# Work Order ID 66095

Item Name: 205 Skidtube bent detail

DRAWING NO. D2580	TITLE 205 SKIDTUBE ASSEMBLY	REV. D	DART AEROSPACE LTD ENGINEERING ORDER		D.E.O. NO. D2580-D-1	SHEET NO. SHEET 1 OF 1	SCALE NTS
DRAWN <i>UP</i>	CHECKED <i>L</i>	MFG. APPR. <i>B</i>	APPROVED <i>MP</i>		DE APPR. <i>H</i>		
DATE 10.09.22	DATE 10.11.04	DATE 10.11.04	DATE 10/11/04		DATE 10.11.04

CHANGE ALL WELDED CROSSBOLT SPACERS TO SWAGED SPACERS

SECTION D-D & SECTION H-H ARE AMENDED AS FOLLOWS:

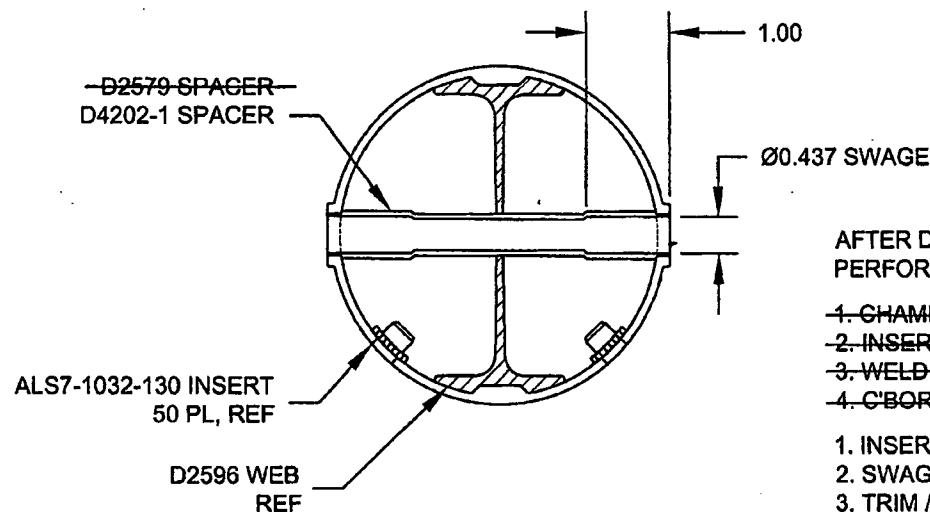
PARTS LIST IS AMENDED AS FOLLOWS:

WAS

QTY	QTY	PART NUMBER	DESCRIPTION
-041	-045		
20	24	D2579	CROSS BOLT SPACER

AFTER DRILLING AND BENDING ASSEMBLY  
PERFORM THE FOLLOWING FOR Ø0.508 HOLES ONLY:

1. CHAMFER HOLE 0.050 X 45°
2. INSERT D2579 SPACER (20 PLACES)
3. WELD INTO PLACE AND GRIND FLUSH
4. C'BORE D2579 SPACER TO Ø0.437 X 1.00 DEEP

IS

20	24	D4202-1	SPACER
----	----	---------	--------

1. INSERT D4202-1 SPACER, 20 PL (-041) OR 24 PL (-045)
2. SWAGE TO Ø0.437 X 1.00 DEEP PER QSI 002
3. TRIM / GRIND FLUSH PER QSI 002
